[Docket No. 2001–SW–40–AD; Amendment 39–12793; AD 2002–13–05]

Airworthiness Directives; MD Helicopters, Inc. Model 369D, 369E, 369F, and 369FF Helicopters

ACTION: Final rule.

Figure 1 - Inspection Location

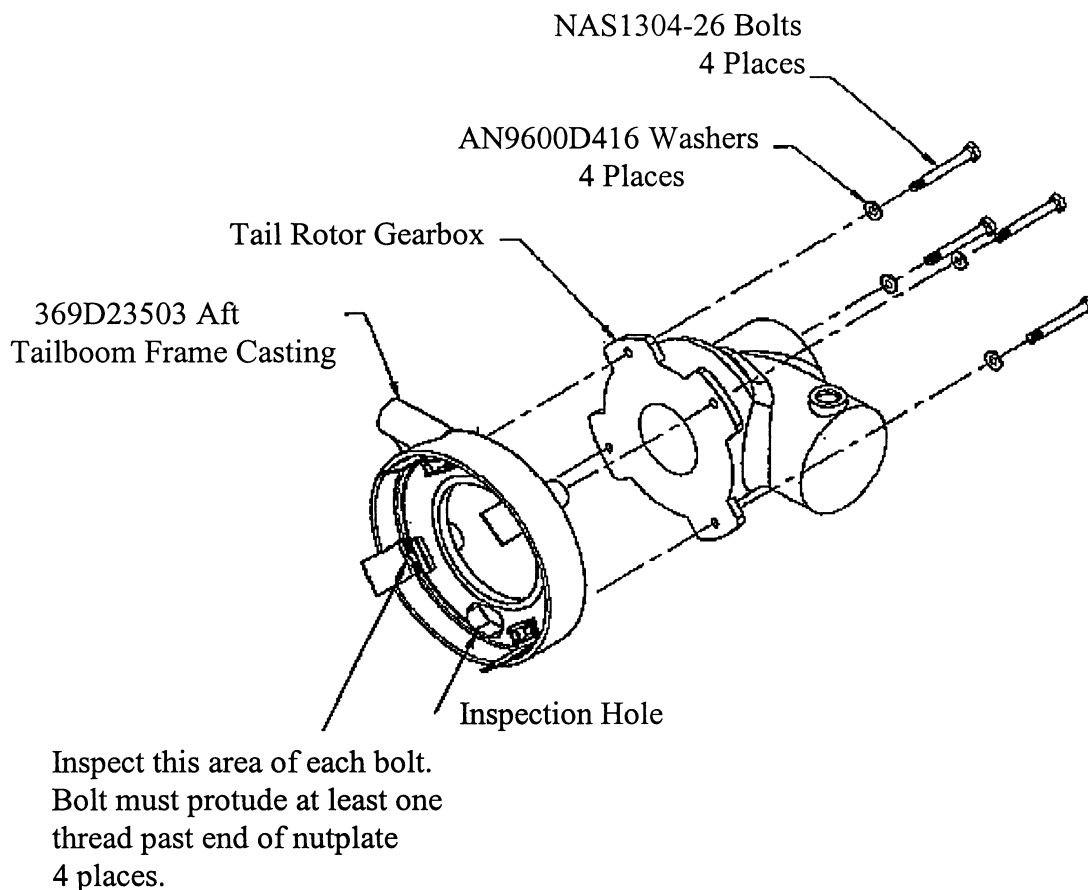
(2) Remove the tailboom control rod and determine the number of bolt threads protruding from each nutplate on the internal surface of the aft tailboom frame casting, P/N 369D23503, as shown in Figure 1 of this AD. At least one thread must protrude. If more than four threads protrude, add an additional washer, P/N AN960D416, under the bolt head. Torque the bolt to 100-110 in-lbs, and reapply a slippage mark. See Figure 1:

After careful review of the available data, including the comment noted above, the FAA has determined that air safety and the public interest require the adoption of the rule as proposed. However, we have added introductory language for Figure 1 and placed Figure 1 directly after the AD paragraph in which it is referenced. We have determined that these changes will neither increase the economic burden on any operator nor increase the scope of the AD.
